The Committee of 100  
on the Federal City

RE: Section 106 Review Comments on the October 2017 *C&O Canal Concept Plan*

### COMMITTEE OF 100 ON THE FEDERAL CITY COMMENTS/ QUESTIONS – C&O CANAL CONCEPT PLAN

Figure 1. Cross section of the C&O Canal through Georgetown (National Register nomination, 1979).

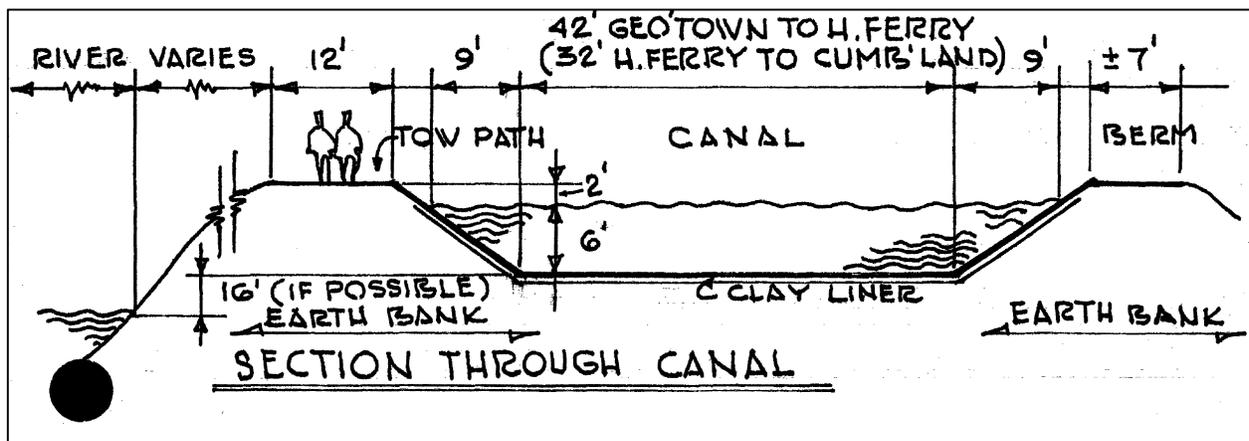
The span of the canal running from Georgetown to Harper’s Ferry consisted of a 16’-wide earthen bank, narrowing to a 12’-wide towpath on top along the river side of the canal. An earthen berm to contain the other bank of the canal provided a 7’-wide path on the top (see Figure 1).

From Georgetown to the Alexandria Aqueduct, a specified 12' towpath was on the berm (land side) of the canal, and at that point a bridge afforded access to the towpath on the river side of the canal for all the remaining miles. Throughout parts of Georgetown, over time stone walls and foundations abutted and/or encroached on the towpath, creating narrower traffic areas.

The proposed Alternative A, while keeping the existing towpath width, proposes to add new material on top of the existing canal wall to stabilize it, as well level the path and resurfacing it (see Secretary of the Interior's *Treatment of Historic Properties* ("Treatment") Standards 5 and 6 and Rehabilitation Standards 6 and 9). Alternative B proposes applying a cantilevered edge over the canal wall, covering it, and extending the walkway over the canal itself. Both Alternatives A and C would alter the historic spatial relationship between the canal and towpath and make it impossible to distinguish the old from the new (see Secretary of the Interior's *Standards for Rehabilitation* ("Rehabilitation"), Standard 9). Alternative C proposes to widen the towpath by moving the wall further into the historic canal, thus narrowing the canal – a modification that would be irreversible (*Rehabilitation* Standard 10).

The towpath was specified to have a smooth, hard surface and surfacing was of crushed rock or whatever was available in the immediate area. This would have been either gravel, crushed stones ("Macadamized"), or simply dirt. Resurfacing the towpath with concrete or another material, as well extending the width of the path with what appears to be either granite or concrete slabs is introducing historically inappropriate materials.
